From: Lemont, Stephen
Sent: Monday, November 30, 2015 9:39 AM
To: 'Cherry, Robert N CIV USARMY IMCOM HQ (US)'
Cc: skibinskij@leidos.com; James Prikryl; aminor@swri.org; Pat LaPlante (plaplante@swri.org); gwalter@swri.org
Subject: NRC Questions and Clarification Requests on Army's 10-1-15 JPG EIS RAI Responses and Related Matters
Attachments: NRC QUESTIONS AND CLARIFICATION REQUESTS ON ARMY'S RAI RESPONSES FOR JPG DU IMPACT AREA EIS, NOV. 30, 2015.pdf

**NRC QUESTIONS AND CLARIFICATION REQUESTS ON
U.S. ARMY'S REQUEST FOR ADDITIONAL INFORMATION RESPONSES
FOR JEFFERSON PROVING GROUND DEPLETED URANIUM IMPACT AREA
ENVIRONMENTAL IMPACT STATEMENT
NOVEMBER 30, 2015**

Figure 6-2 (U.S. Army, 2013)
Figure 5-2 (SEG, 1996)
Figure 5-1 (SEG, 1995)
Figure 3-5 (SEG, 1996)

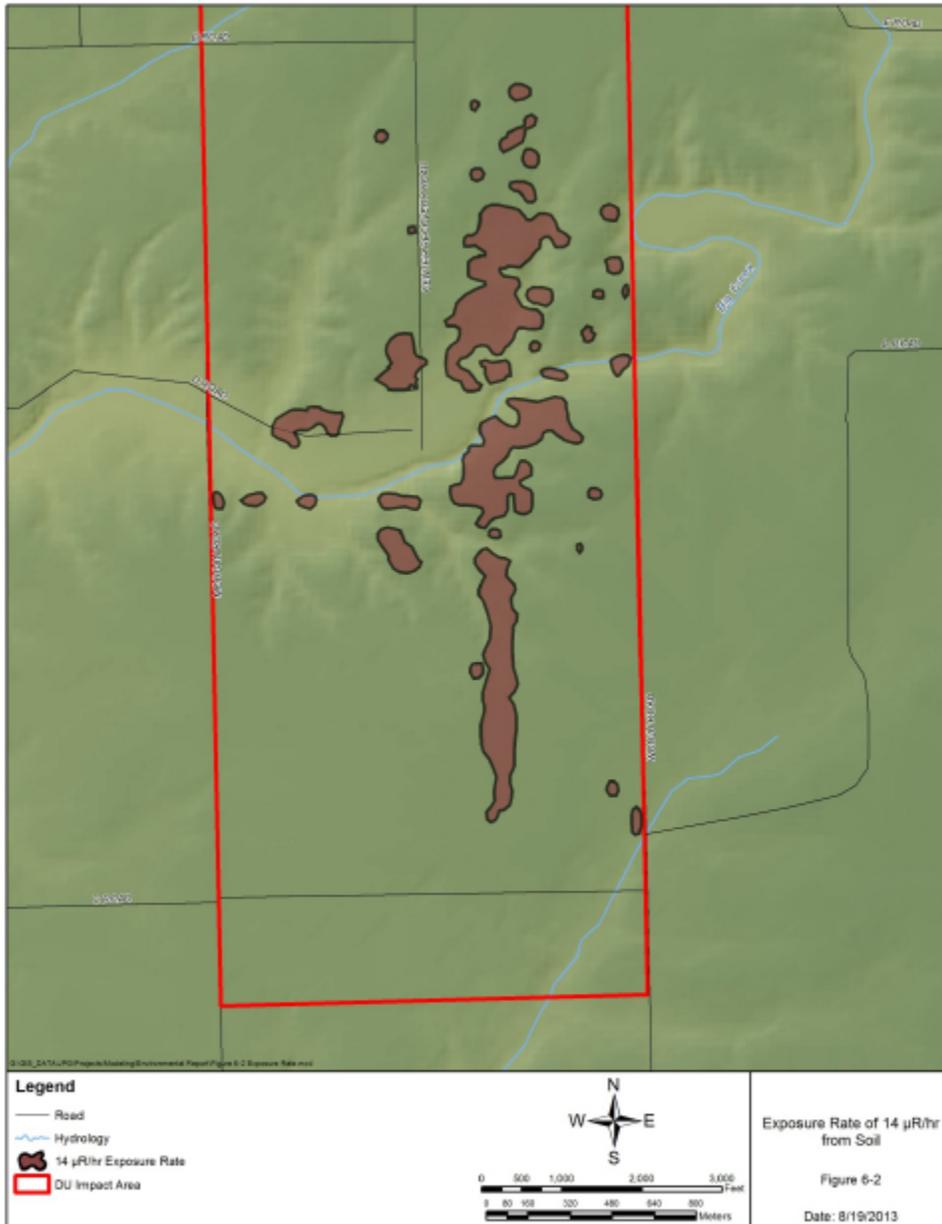
NRC staff could not locate the information presented and described in ER Figure 6-2 in the cited Scientific Ecology Group, Inc. (SEG) reference document, “*Jefferson Proving Ground Depleted Uranium Impact Area: Characterization Survey Report*” (SEG, 1996). **Review the caption and reference for Figure 6-2 in the ER (U.S. Army, 2013) and provide any necessary corrections or clarifications to ensure the data being presented in the figure match the caption and the cited reference.**

Based on NRC staff’s review of available Army site characterization information for the DU Impact Area, staff believe that ER Figure 6-2 may be showing the gamma exposure rate measurements within the DU Impact Area which exceed the 95 percent confidence interval about the mean of all gamma exposure rate measurements rather than the areas corresponding to a DU concentration of 35 picocuries/gram (pCi/g) as stated in Section 6.1.1.2 on page 6-6 of the ER (U.S. Army, 2013). NRC staff consider the “95 percent confidence interval” information to be useful for broadly describing the areas within the DU Impact Area that have elevated concentrations of DU, but need a clearer understanding of information that is being presented in ER Figure 6-2 as well as the origin of that figure. The following paragraphs provide additional details.

The Army’s cited source for ER Figure 6-2, “Exposure Rate of 14 μ R/hr from Soil” (see attached below), is SEG (1996). Section 6.1.1.2 on page 6-6 of the ER text describes what is presented in the figure as follows: “*The exposure rate corresponding to a DU concentration of 35 pCi/g is 14.4 microRoentgens per hour (μ R/hr). The contour map showing areas with an exposure rate greater than 14.4 μ R/hr is shown in Figure 6-2.*” (emphasis added). The closest match that NRC staff located in the cited source document (SEG, 1996) for the above is Figure 5-2 (see also attached below). SEG (1996) Figure 5-2 appears to be conveying the same information according to the figure caption (Figure 5-2, “Affected Area at 35 pCi/gm (14.4 μ R/hr”); however, the marked “affected area” contours on Figure 5-2 are noticeably smaller than those depicted in ER Figure 6-2. The text of Section 5.1 on page 5-2 in SEG (1996) states: “*The exposure rate corresponding to a DU concentration of 35 pCi/g is 14.4 μ R/hr. This value is programmed into the mapping software, to define a new affected area. The resulting affected area contour map based on the exposure rate is shown in Figure 5-2.*” Thus, the captions and descriptions on ER Figure 6-2 and SEG (1996) Figure 5-2 are consistent, but the depicted graphics are different.

Figure 5-1

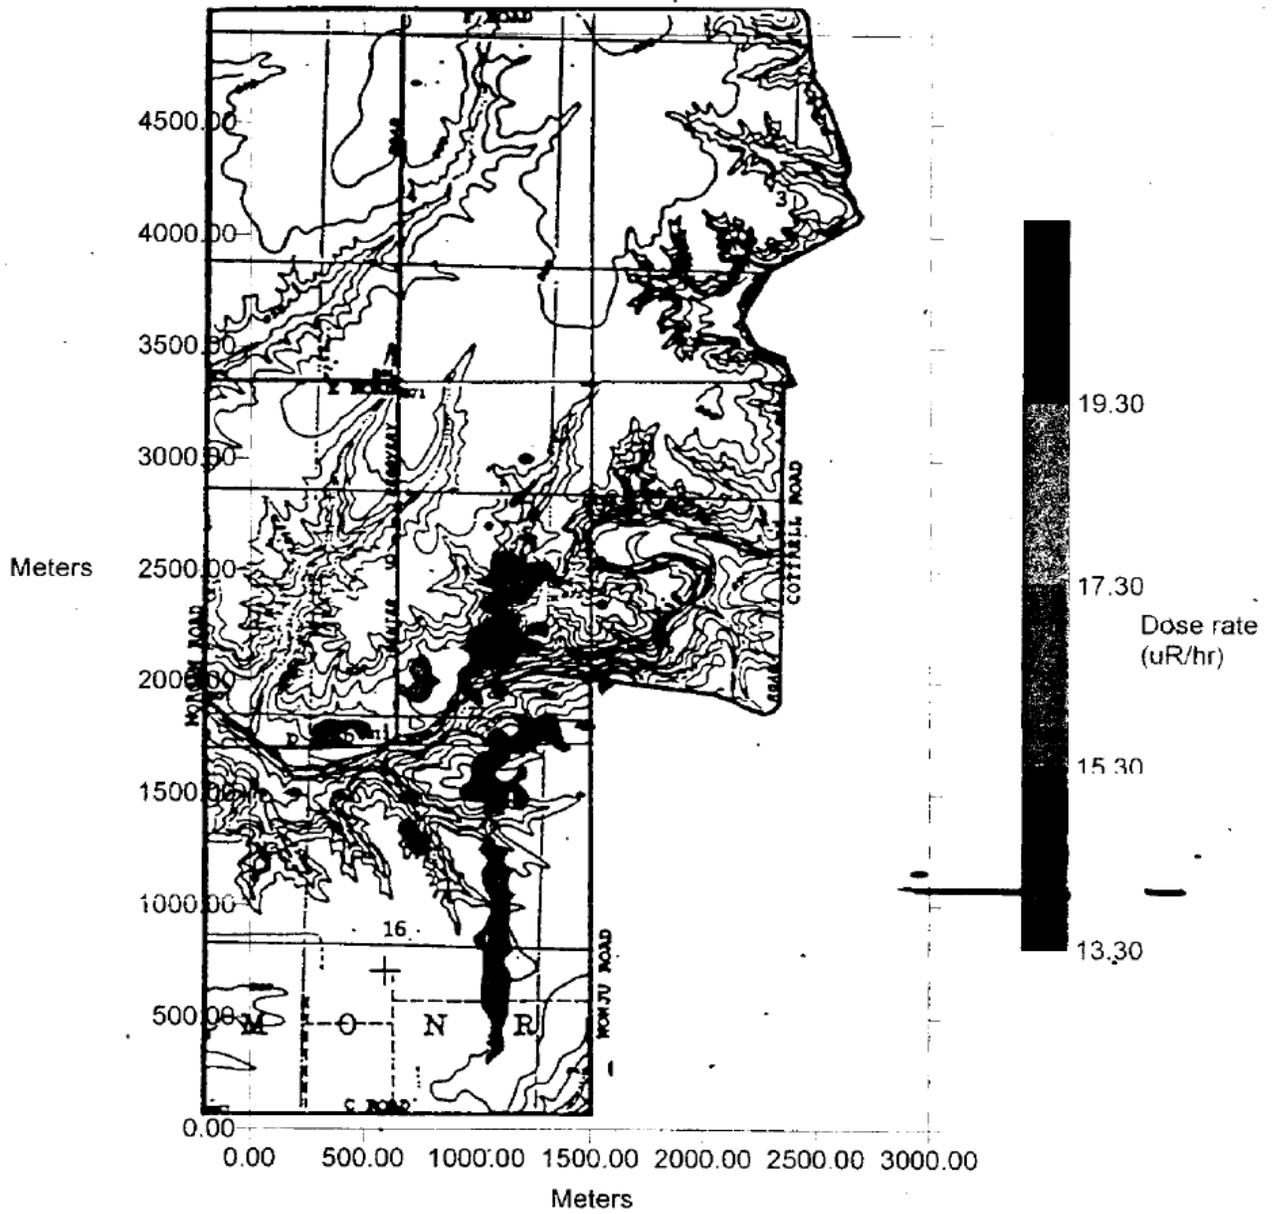
Further evaluation by NRC staff resulted in locating Figure 5-1 (see also attached below) in the “*Jefferson Proving Ground Depleted Uranium Impact Area: Scoping Report*” (SEG, 1995). This figure illustrates information that matches the elevated gamma exposure contours shown in ER Figure 6-2 (i.e., the same or very similar data are presented). The caption of Figure 5-1 in SEG (1995) is “*Impact area with dose rates greater than or equal to 13.3 μ R/hr*” (emphasis added). The text of Section 5.0 on page 5-2 of the SEG (1995) report describes Figure 5-1 as follows: “*...the radiation contour map for the 95% confidence level upper bound is shown in Figure 5-1. The areas shown are considered to be affected areas for the JPG firing range.*” The contours presented in SEG (1995), Figure 5-1 are those radiation measurements that were

Figure 3-5
Random Soil Sample Locations
(Sample taken at center of 50 meter Square Grid)

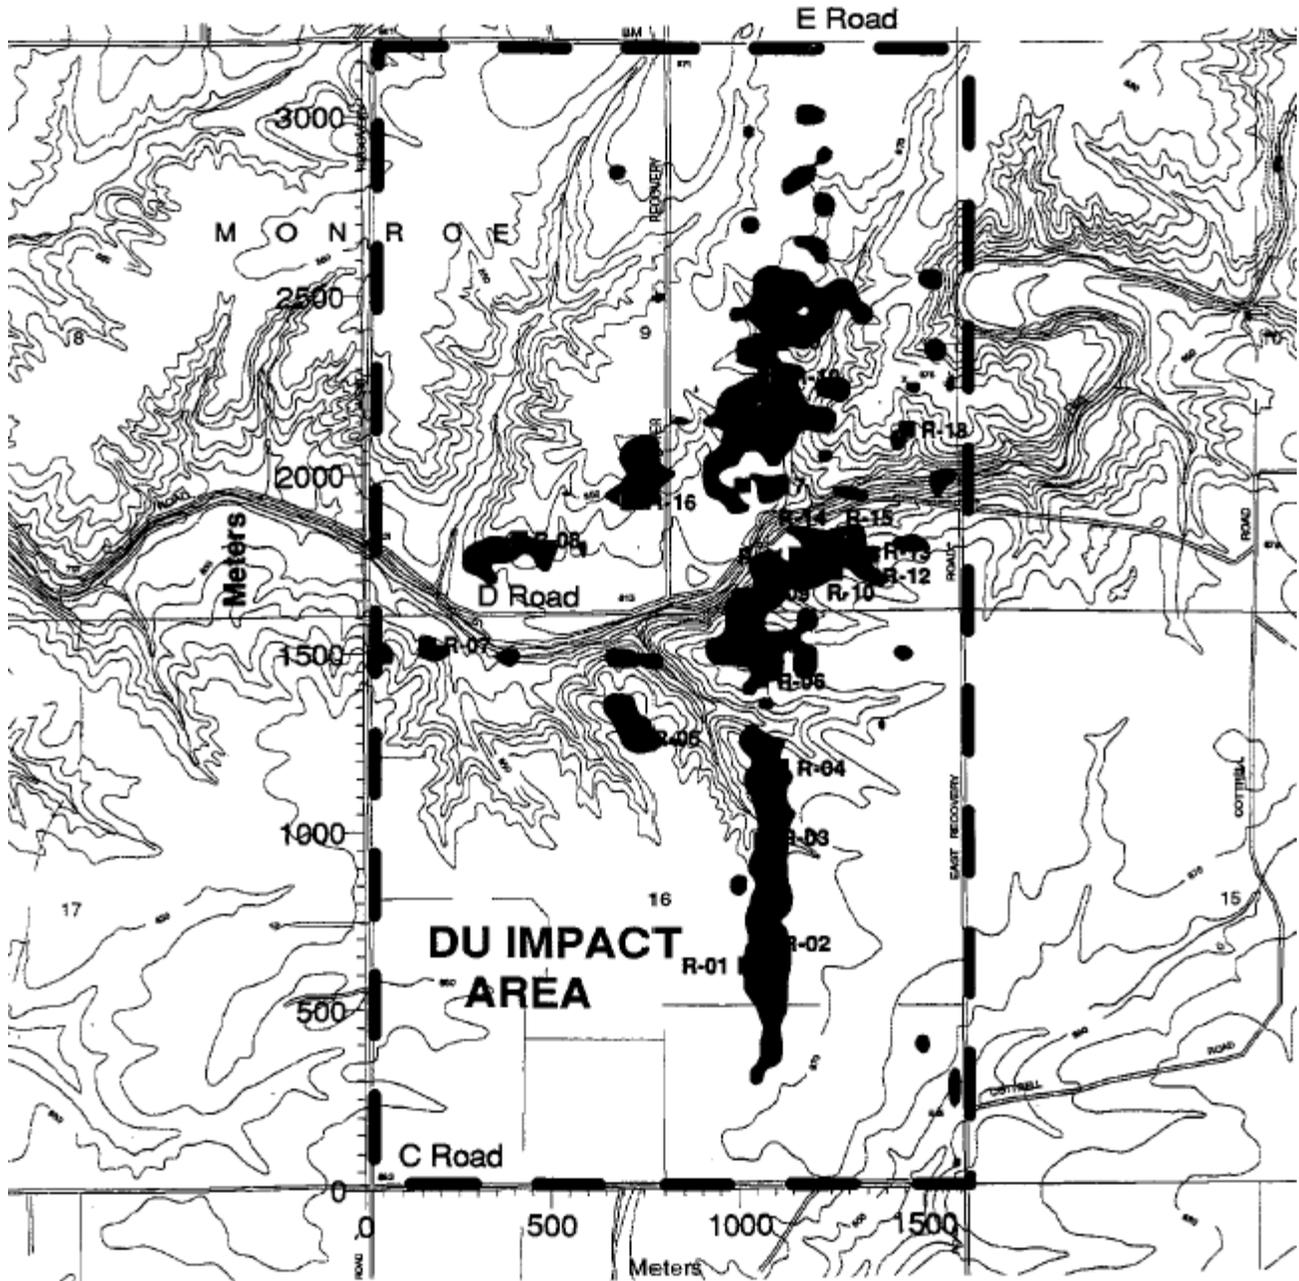
at or beyond the upper bound of the 95% confidence interval about the mean of all 25,098 gamma measurements in the DU Impact Area. Additionally, the SEG (1996) report shows what appear to be the same contours depicted on a clearer graphic, Figure 3-5 (see also attached below); however, Figure 3-5 is used to show soil sampling locations and the text of SEG (1996) does not specifically describe the contour information in that graphic. In summary, the contours of both figures SEG (1995) Figure 5-1 and SEG (1996) Figure 3-5 appear to match the contour data depicted in ER Figure 6-2 but not that figure's caption.
